The Sea Ranch Association

CSA 41 Zone 2
On-Site Wastewater Disposal Zone

RE: Draft Waste Discharge Requirements or Sonoma County Service Area 41, Zone 2, Sea Ranch Association Onsite Wastewater Management Zone Order Number R1-2017-0014

Sea Ranch Monitoring Wells

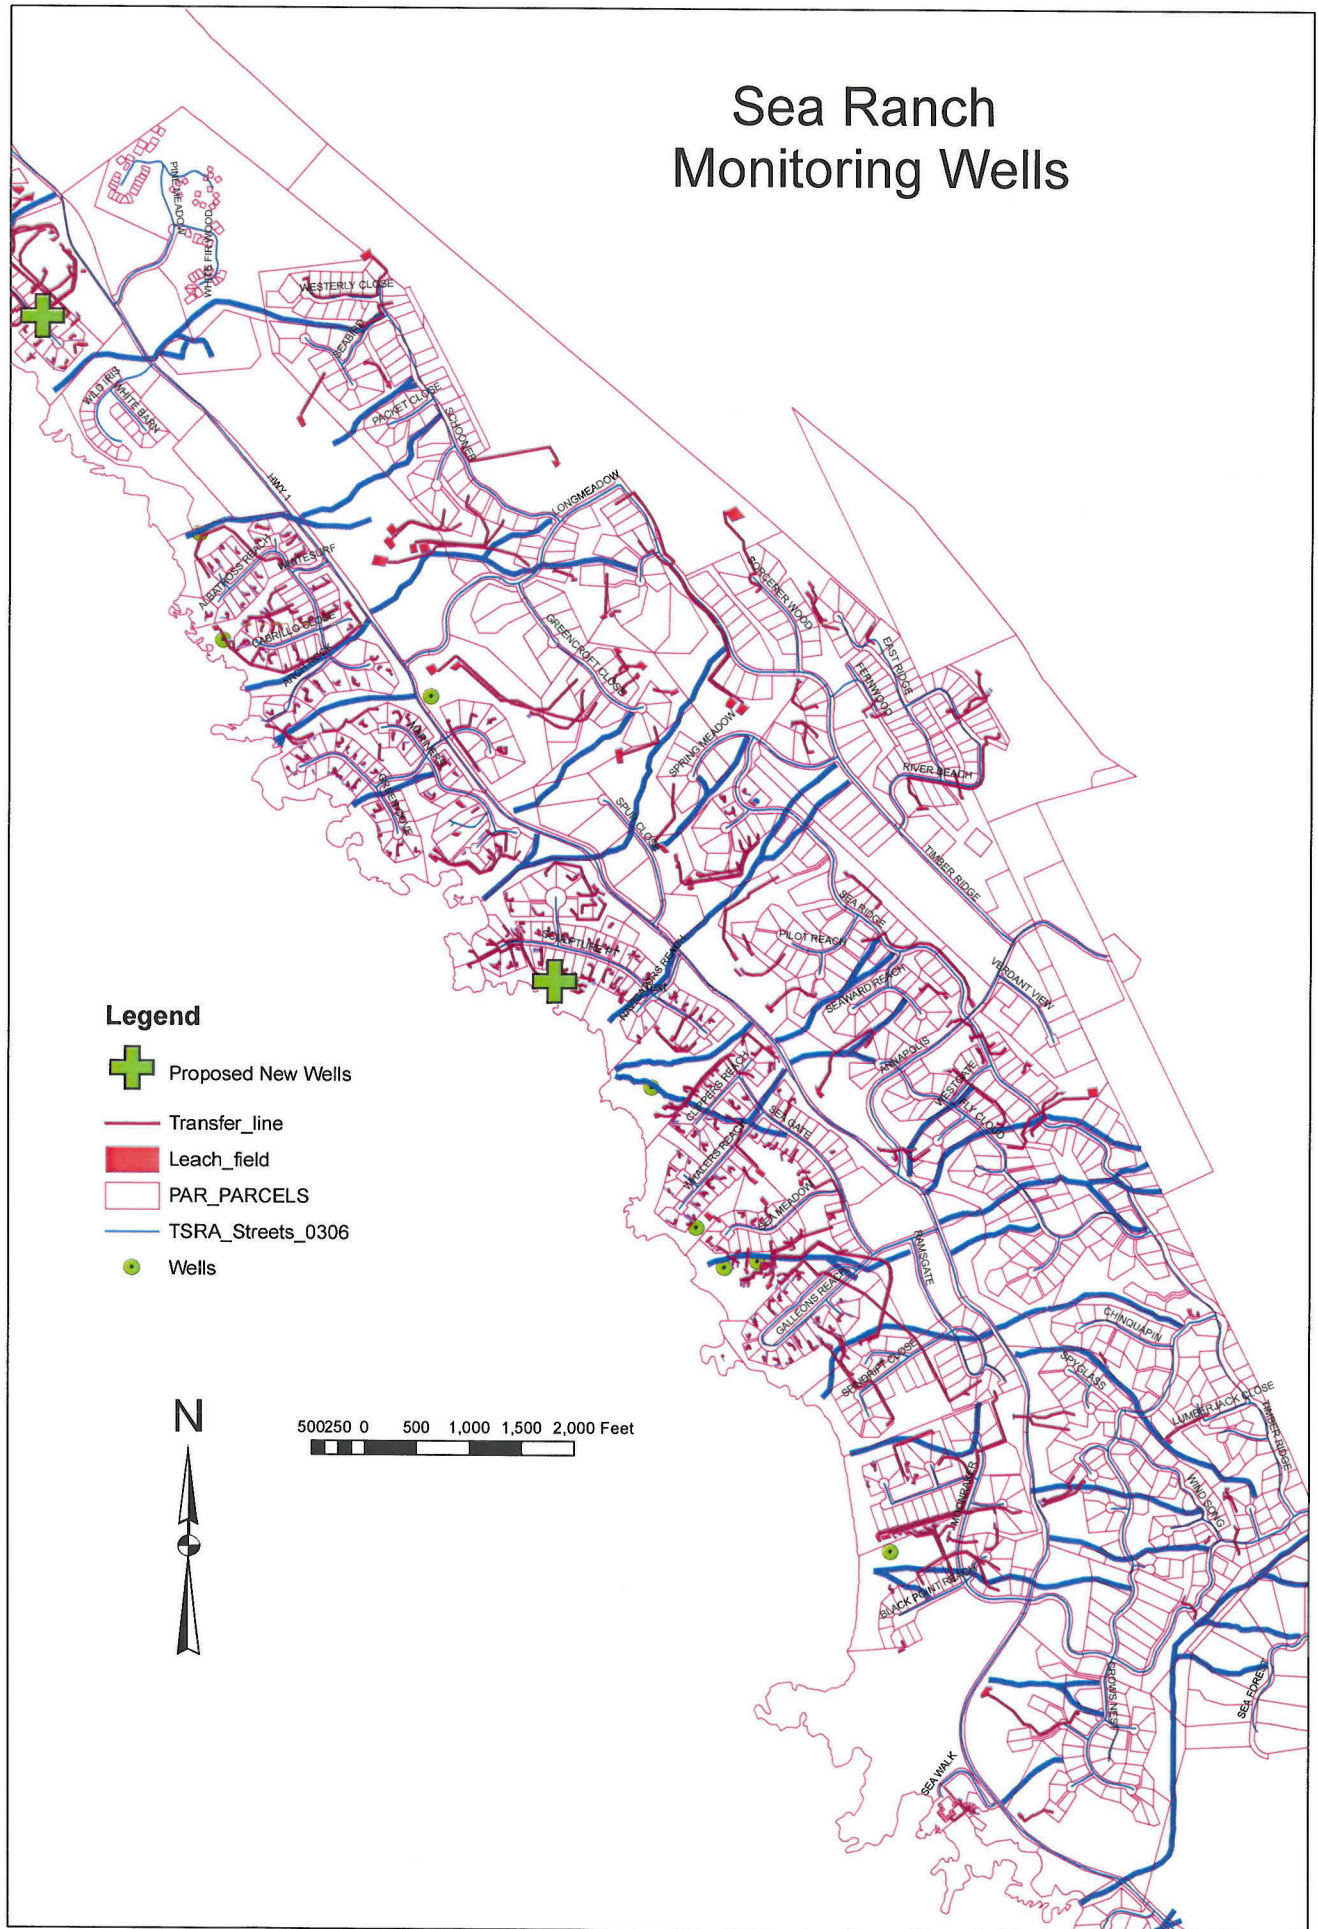
6. Attachment B-Monitoring and Reporting Program, II D: Suggest it should read "Ground water well water measurements and groundwater constituent sampling are to be the primary indicator of achievement of applicable water quality objectives. Supplemental and supportive surface water monitoring may be conducted on a regular basis to support findings of causative factors of contamination within groundwater monitoring wells. Surface waters that exhibit similar qualitative values of samples taken upstream and downstream of a study area may be subject to deletion in reporting requirements."
And III.E added as "Ground water well sampling sites to be increased in number at locations shown in Exhibit B-2."
